(Revised Site Plan & Tree Preservation & Replacement Plans)

Re: Rezoning Application of The Woodbery Group, LLC to Rezone a 2.02 acre tract from O&I to RM-12 (No. Z18-006)

2885 Elmwood Drive

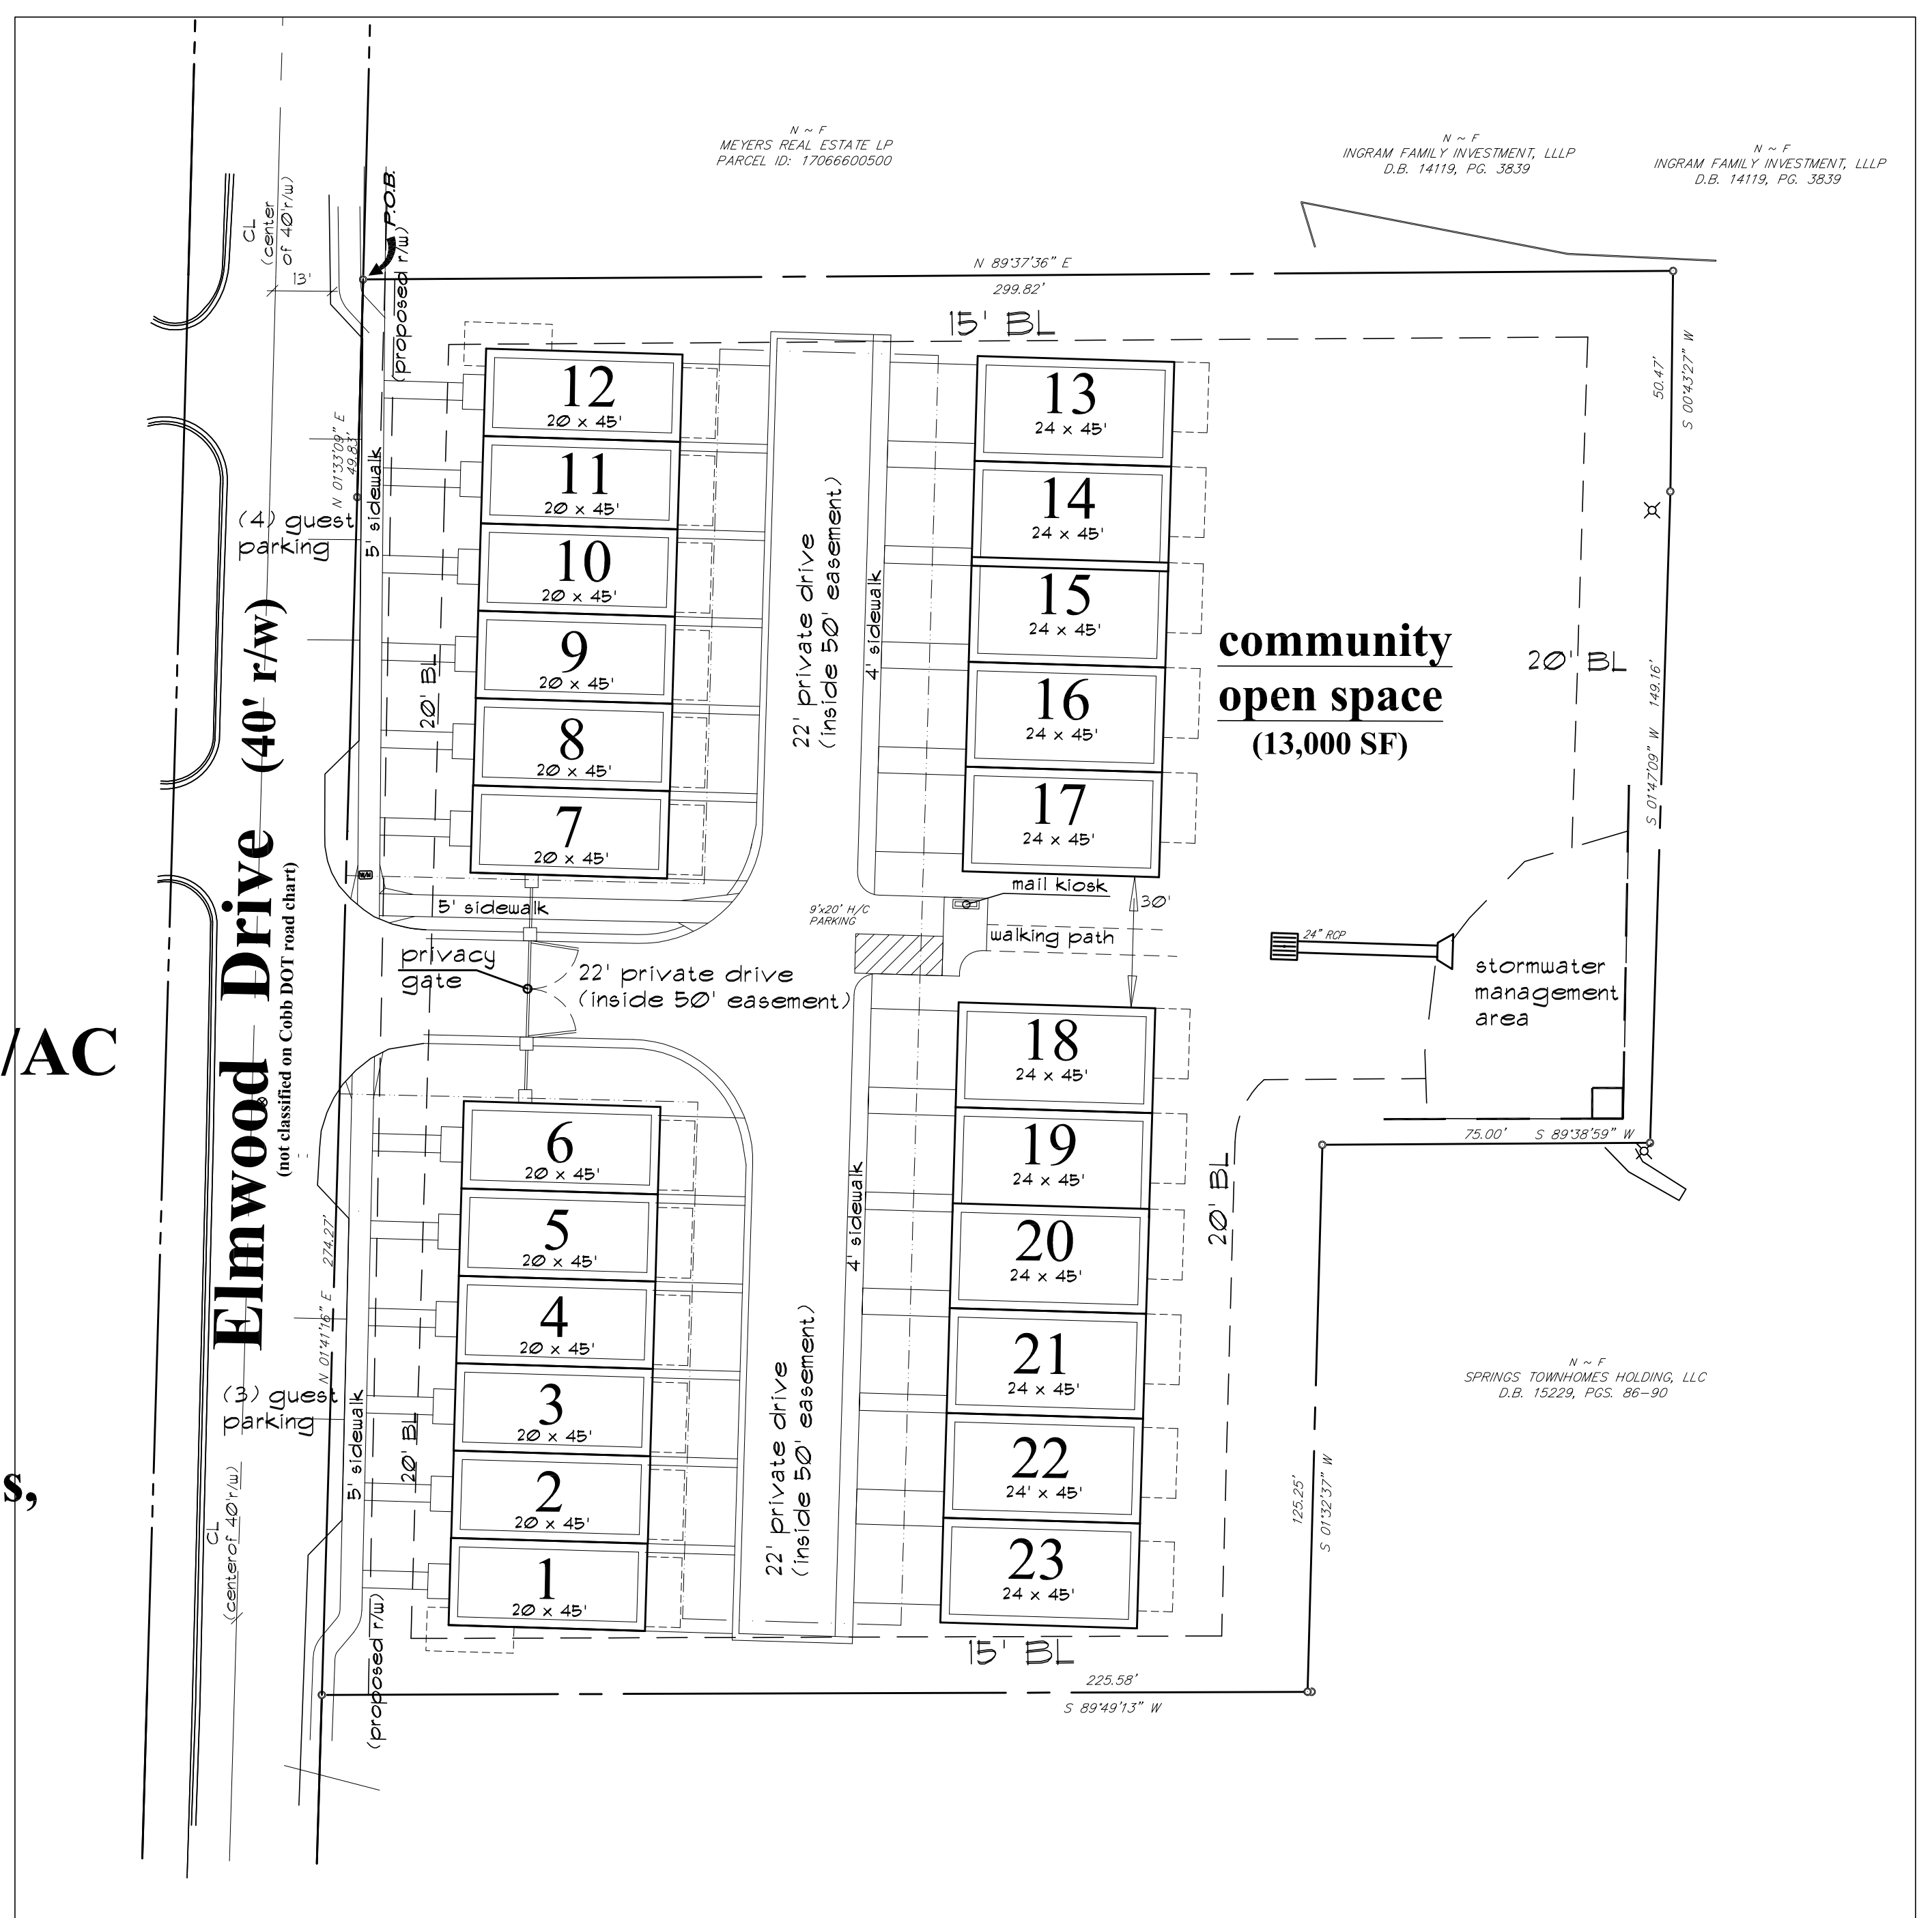
As engineering work continues and the proposed project is refined, it has been determined that the two (2) guest parking spaces located at the end of the alley are not feasible due to the topography and necessary grading. To address this, an additional parallel parking space has been added to the front of the project; creating a net loss of one (1) guest parking space.

Additionally, the Engineer has determined there is a need to dedicate ten feet (10’) of right-of-way to clear the sidewalks along Elmwood Drive instead five feet (5’) as contained in the March 28, 2018 stipulation letter, thereby amending stipulation no. 13(a) as follows:

13. Compliance with the recommendations from the Public Works Director, as follows:
 - a. The voluntary donation and conveyance of ten feet (10’) of right-of-way on Elmwood Drive; however, the front setbacks shall be measured from the existing right-of-way of Elmwood Drive.
